INDESIT company

Model type:
BCS312AEU

Commercial code:
F026851

Notices

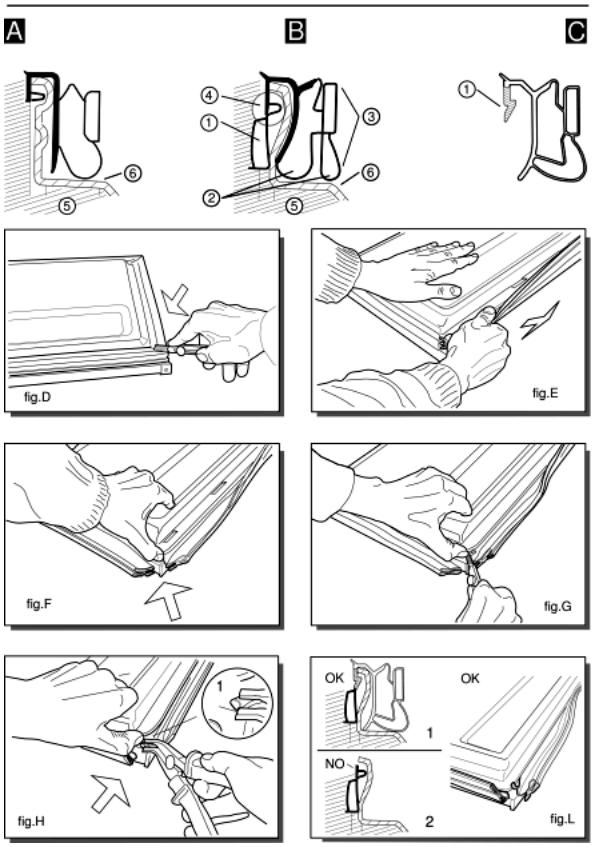
0522067: SEALS FOR DOORS FOAMED AS ONE PIECE

Various types of gaskets with different profile, as shown in figures (A) and (B), are used to fix the door (fig. A-5; B-5) and the inner door (fig. A-6; B-6) on the block foamed doors of combined freezers and refrigerators.
---Ilpea profile 245; 179; 412 (fig.A)
---Ilpea profile 287 (fig.B)
When replacing gaskets with profiles 245; 179; 412 these are fixed with screws (2 per corner) to the door.
Gaskets with profile 287 can not be used as spare parts but are designed to house the Ilpea type 900 gaskets (see figure C).
When replacing the gasket (287), once it is removed you will find a pocket (fig. B-1) between the door and inner door.
The rigid tooth (fig.C-1) of the gasket (900) is inserted inside between the pocket and the inner door, doing away with the need for screws.
Gasket with profile 287 is easy to identify since it has an exterior double edge (fig.B-2) which acts as a cushion when the door is closed.

To replace this gasket, follow these steps:
---Dismount the door and cut the four corners of the gasket along the joint (fig.D);
---lift the gasket and pull it carefully along its full length without tearing it (fig.E).
The purpose here is to detach the inner door slightly from the foam along the exterior edge for a depth equal to that of the gasket (fig.B-3);
---lift the corner of the inner door slightly, prising it up with your thumb (fig.F). Do not use a tool which might break the inner door;
---continue cutting the gasket inside the inner door for about 6 mm (fig.G);
---push in the tip of the pliers (type USAG N131) and pull outwards until you see the top edge of the pocket (fig. B-4) which is empty (fig.H-1);
---if you carry out this operation correctly (fig.L) you will be able to pull off the top edge of the pocket for the full length of the door.
If the gasket tears before the top edge (fig. L-2) you should repeat this operation from the other corner of the door.

---once the gasket (287), has been removed the space above the pocket (fig. L-1) can house the rigid tooth (fig. C-1) of the gasket 900.
When you fit this gasket ensure that it lies flush against the edge for the full length of the door.
If the rigid tooth is difficult to fit, eliminate any residues of foam between the door and the inner door in the gasket area.
fig.5131549A

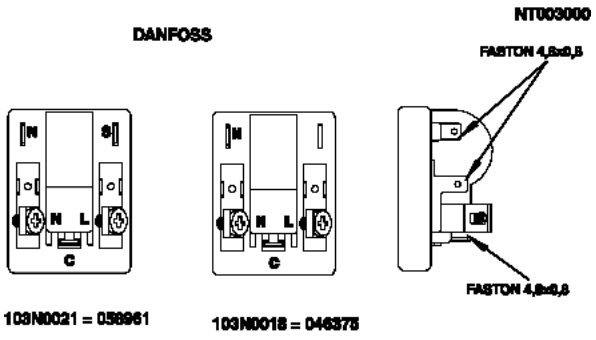
n1025079: Danfoss compressors with running condenser

The equipment (klixon + PTC) marked 103N0021 (part no. 058961) must be assembled onto the Danfoss compressors with running condenser. This equipment has connections (N) and (S) on the top to connect the running condenser (see figure

NT003000).
On those Danfoss compressors that do not use the running condenser, the equipment 103N0018 (part no. 046375) is assembled, and the latter is different from the previous one in that it only has connection (N) at the top.
Danfoss compressors NLE7F - LE8FK - TLES4F at 220-240V/50Hz can be equipped with both the equipments, depending on the model onto which they are assembled.
For this reason, the 3MF running condenser (058962)(Rohs 144813) on compressor NLE7F is provided with the compressor (064646), but its use is subordinated to whether the component is actually present on the product on which the replacement of the compressor must be carried out. For example, if this replaces the Danfoss NL7F (052118), the condenser must not be used.
Looking at the compressor assembly, the running condenser can be assembled either on the cross piece of the compressor, or on the side of the cabinet. To fasten it, the plate (046312) is used.

N130084FIG1

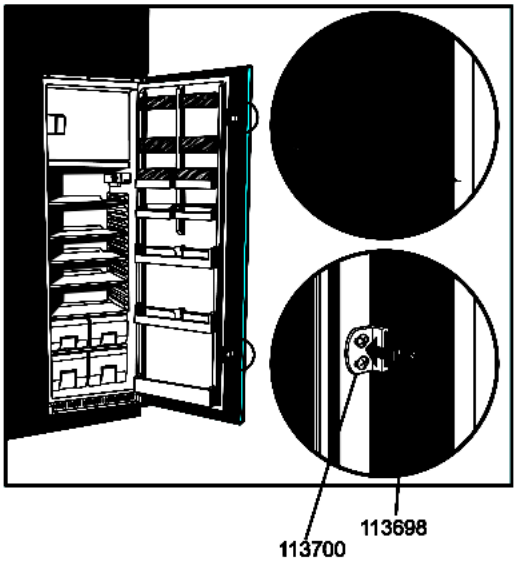
n1030096: Replacement of Atea A13-0645 thermostat with Atea A13-0552 on built-in combis

From serial number 509270001), the Carinaro factory has installed the Atea A13-0552 thermostat used on 330 litre built-in combis on the 310 litres one as well.
The new thermostat improves performance at all ambient temperatures and can also be installed on premodification models.

Parts affected
075113(Rohs 143431) - THERMOSTAT A13-0552 CENTER POST LENGTH 1400

Parts replaced
098393 - THERMOSTAT A13-0645 CENTER POST (LENGTH 1400)
